Access Compliance Report

Public Rights-of-Way

Intersection ID: 25211	Main Street: SMITH_RD	Cross Street: SOUTHBRIDGE_FOREST_DR	Location: SW
ADA ID: 81C83D1E9C44	Ramp Type: BlendTrans2	Initial Pass/Fail: Fail	Overall Compliance: No
		Severity Score: 21.25

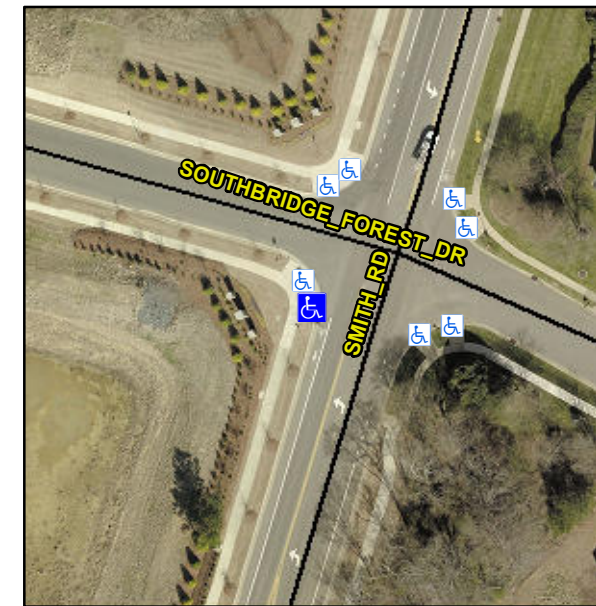
R304.5.1, R304.5.3

Compliance	Description	Data	Compliance	Description	Data
N/A	Ramp Length (in)	167.0	Yes	BlendTrans Slope (%)	1.0
No	Ramp Width (in)	47.0	No	BlendTrans XSlope (%)	5.1
N/A	Flare Type LT	N/A	N/A	Flare Type RT	N/A
N/A	Flare Slope LT (%)	N/A	N/A	Flare Slope RT (%)	N/A
N/A	Flare Traversable LT?	N/A	N/A	Flare Traversable RT?	N/A
N/A	Landing Length (in)	N/A	N/A	DWS Provided?	N/A
N/A	Landing Width (in)	N/A	N/A	DWS Contrast?	N/A
N/A	Landing Slope (%)	N/A	N/A	DWS Length (in)	N/A
N/A	Landing X Slope (%)	N/A	N/A	DWS Full Width?	N/A
N/A	Landing Curb? (Y/N)	N/A	N/A	DWS Offset (in)	N/A
N/A	Shared Landing?	N/A			
N/A	Gutter Ponding?	N/A	N/A	Gutter Slope (%)	N/A
N/A	Gutter Lip Ht (in)	N/A	N/A	Gutter X Slope (%)	N/A
N/A	Painted X Walk1?	No	N/A	Painted X Walk2?	N/A
	X Walk 1 Direction	To SE		X Walk 2 Direction	N/A
	X Walk 1 Width (in)	N/A		X Walk 2 Width (in)	N/A
	X Walk 1 Slope (%)	1.3		X Walk 2 Slope (%)	N/A
	X Walk 1 X Slope (%)	2.6		X Walk 2 X Slope (%)	N/A

Remove & Replace Curb Ramp With Two New Directional Ramps or Equivalent.
